**URBAN DESIGN REPORT
SITE PLAN APPLICATION**

**32 OAK STREET
COLLINGWOOD ONTARIO**

December 23, 2020

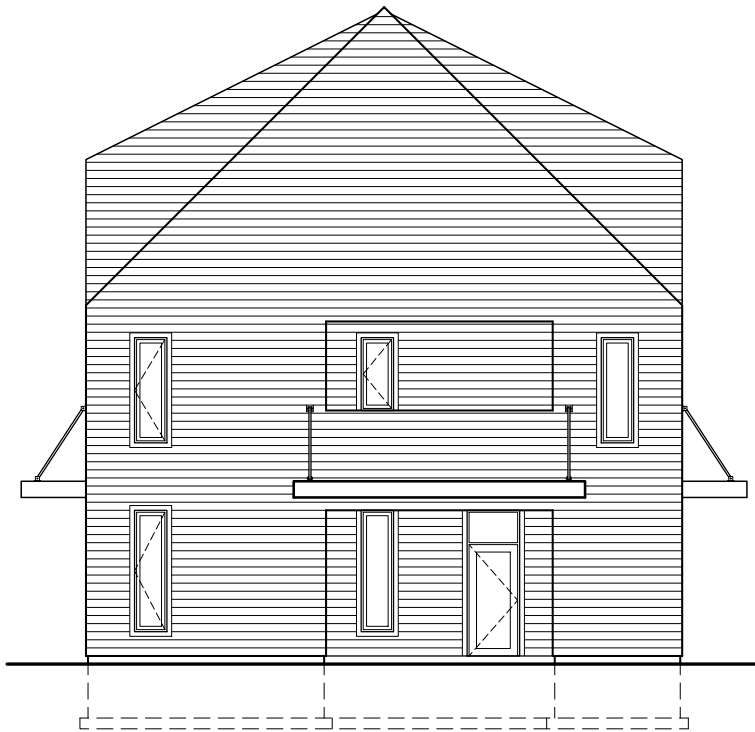
COMMENT #27: Based on the Official Plan policies, Zoning By-law provisions and Urban Design standards outlined above, it is the opinion of Planning Services that the development proposal is too intense for the size and configuration of the subject property and the overall neighbourhood context. The applicant is encouraged to revise the development proposal to a scale that is more appropriate and that better conforms to the applicable planning policies and provisions.

RESPONSE: IN RESPONSE TO THE ABOVE COMMENTS THE 3RD FLOOR HAS BEEN REDUCED AND REDESIGNED TO BE INCORPORATED INTO THE ROOF LINE THEREFORE REDUCING THE MASSING OF THE BUILD TO PROVIDE A MORE RELATIVE SCALE TO THE ADJACENT RESIDENTIAL USES. THE FOLLOWING DESIGN CHANGES HAVE BEEN MADE:

- 3RD FLOOR GFA REDUCED FROM 282.42 SQM TO 167.10 SQM (40% REDUCTION)
- BUILDING LENGTH DECREASED BY 1.5 M FROM 31.55 M TO 29.7 M (6% REDUCTION)
- BUILDING GFA REDUCED FROM 750.27 SQM TO 674.2 SQM (11% REDUCTION)

WHILE THE BUILDING IS LONGER THAN A TYPICAL SINGLE DETACHED UNIT ITS WIDTH AND HEIGHT ARE COMMENSURATE. THE HEIGHT AND LOT COVERAGE PROVISIONS OF THE BY-LAW ARE MET.
